Building Permit Application

Permit No.: B18001515

MEMORANDUM

RE: **7417 Haven Court, Potential Basement Bedroom**

1
A-110
 BASEMENT FLOOR PLAN
 SCALE: 1/4" = 1'-0"
 WIL004aA110
 2,250 SQ. FT.

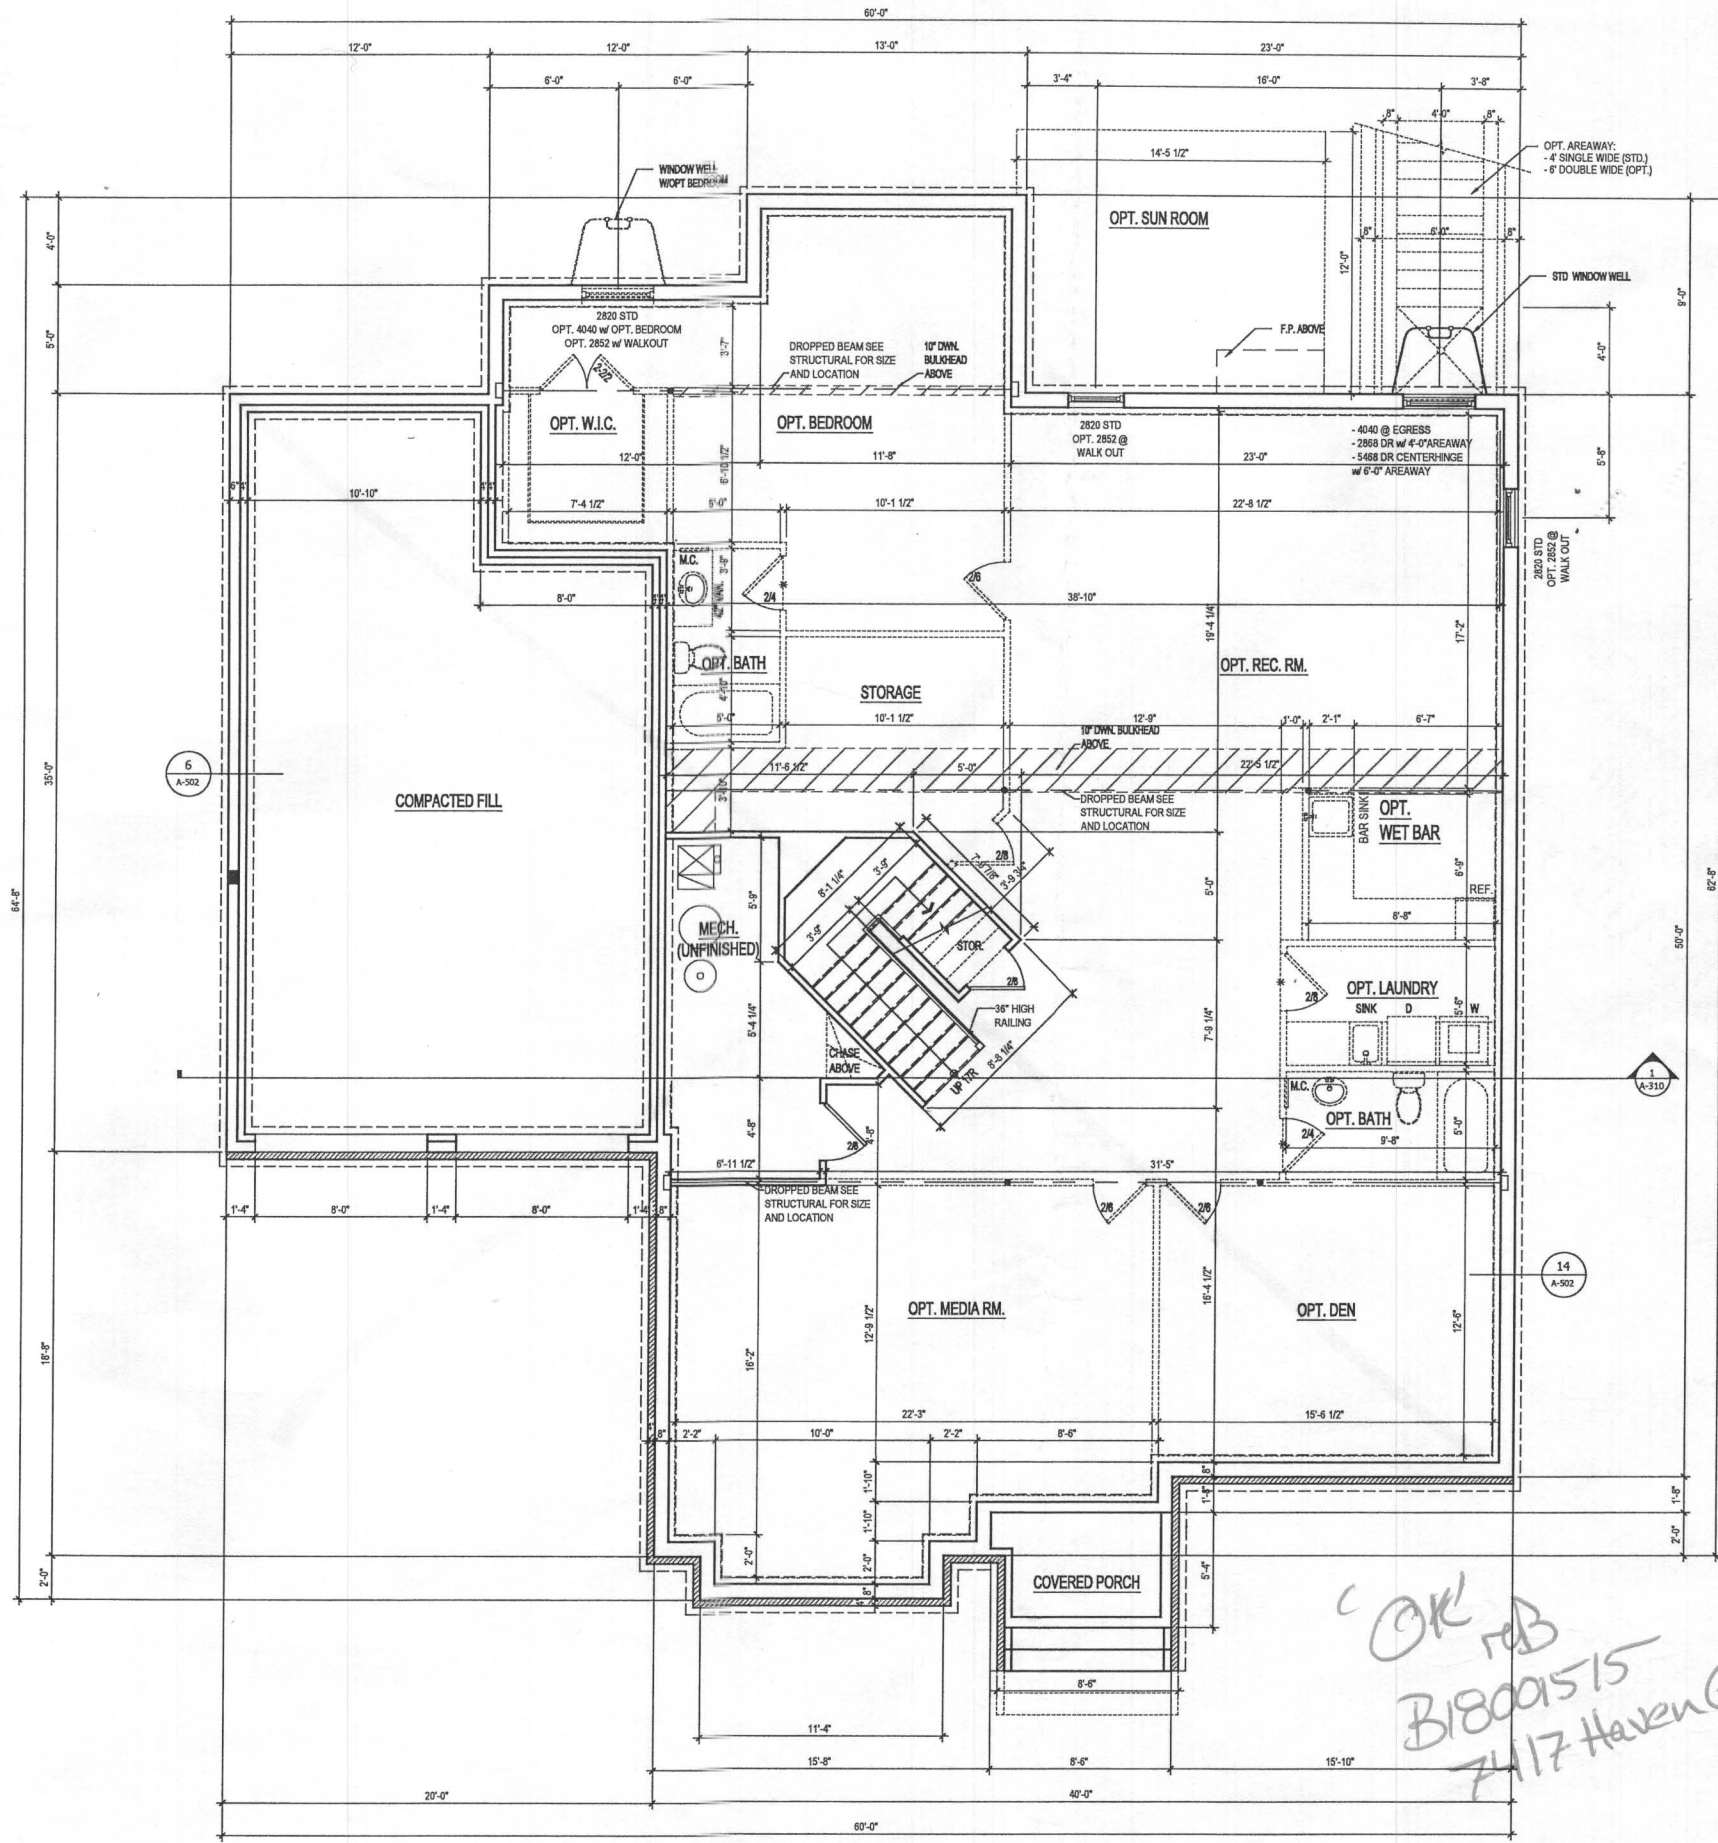
I have reviewed the floor plans in support of Building Permit **B18001515** for a new home at **7417 Haven Court** and noted that there is a full bath in the finished basement. Please note that this makes it very likely for one or more rooms to be considered bedrooms should the future owner choose to modify the design to enclose conditioned space where there is a window.

The Health Department strongly recommends sizing the onsite sewage disposal system at least one bedroom larger than the existing **five (5)** bedroom design to accommodate a future modification of the basement area. If you choose to only size for the existing design, any future building permit for modification of finished space in the basement may be placed on hold until the system is upgraded to accommodate the proposed number of bedrooms. This memo will be retained in the Health Department file for future reference.
